The view of St Paul's from Waterlow Park.

A report for TAG From the Trees and Views group

Test case - the view of St Paul's from Waterlow Park

2036 compared to 2021

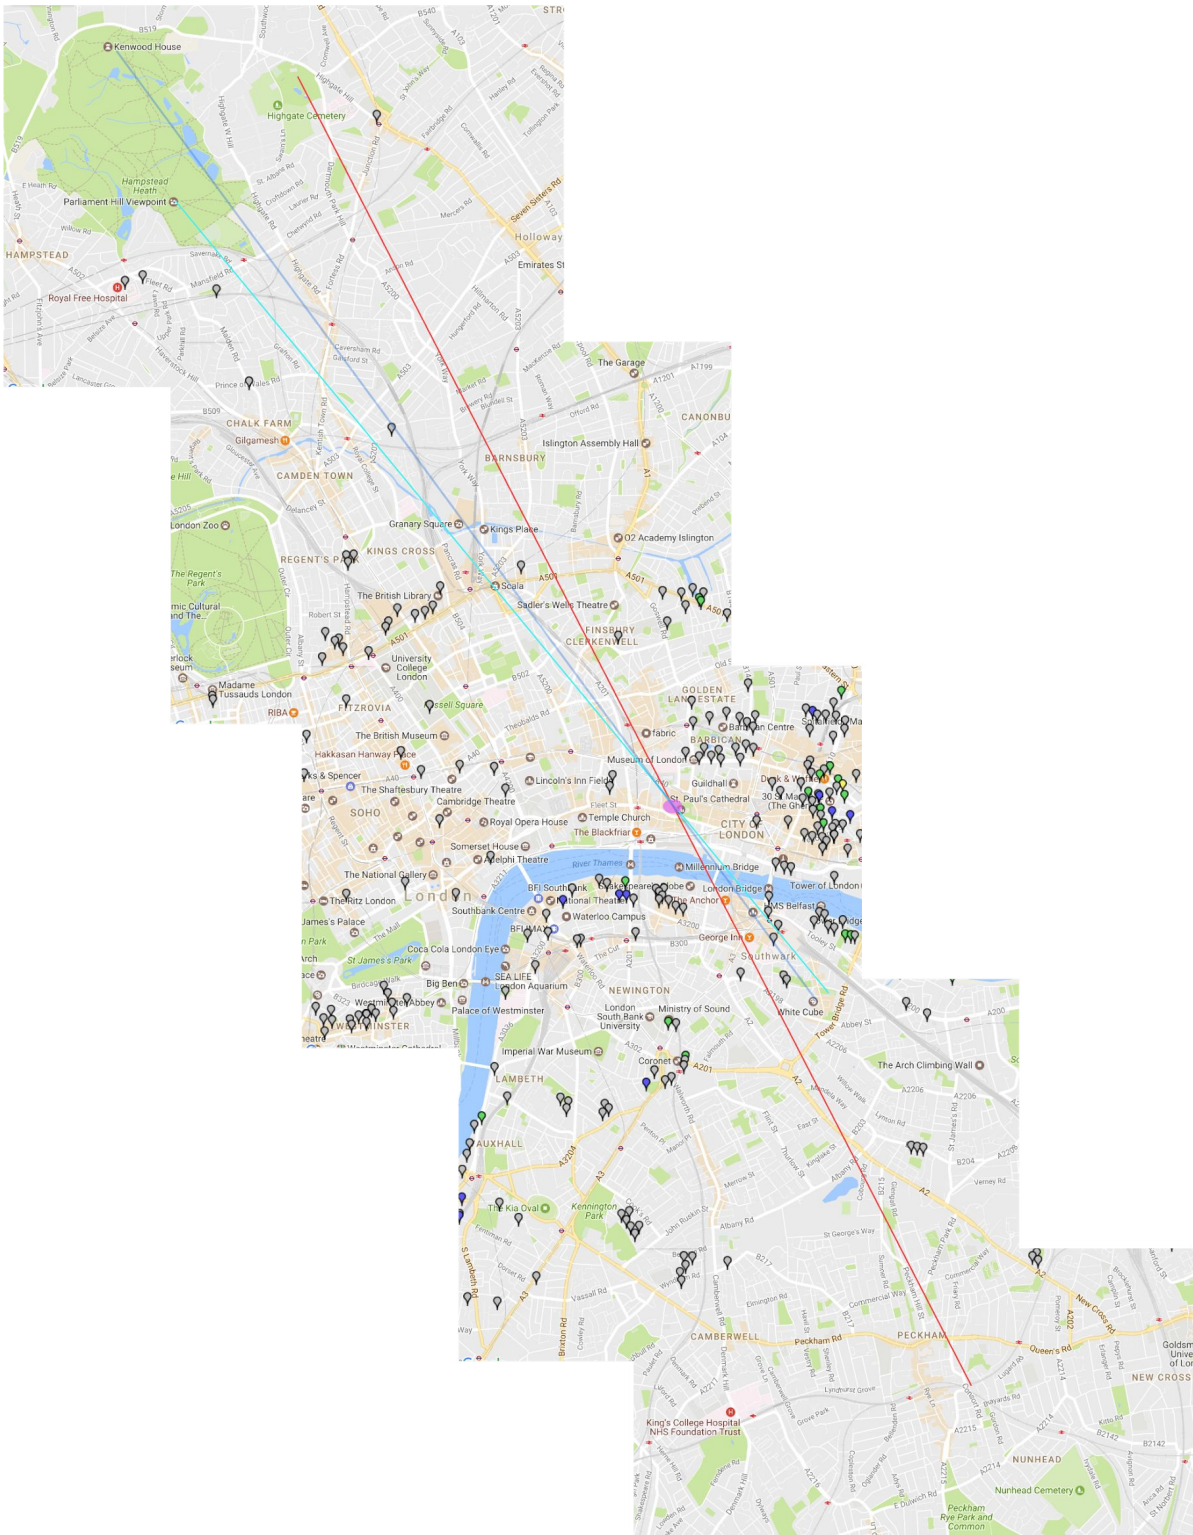
Based on the growth rate of the dawn redwood over the last 10 years the following is a montage showing how it may be anticipated to look in 15 years time if it is left to grow. In the last 10 years it has grown from below the cathedral columns to touch the horizon.

A3. Having considered a reduction of both the oak to the right of the photos² and the dawn redwood in the centre, the Trees & Views group would recommend that the redwood is reduced and reshaped by approx 25% to drop the peak of the tree to below the sight line of the view. Our belief is that the Oak with its associated animals makes a much greater contribution to biodiversity in the park, and that reducing it might stress and threaten the stability of the tree. We also propose crown reducing the lime on the left in order to broaden the skyline and to maintain a view of St Pauls as one moves towards Lauderdale House.
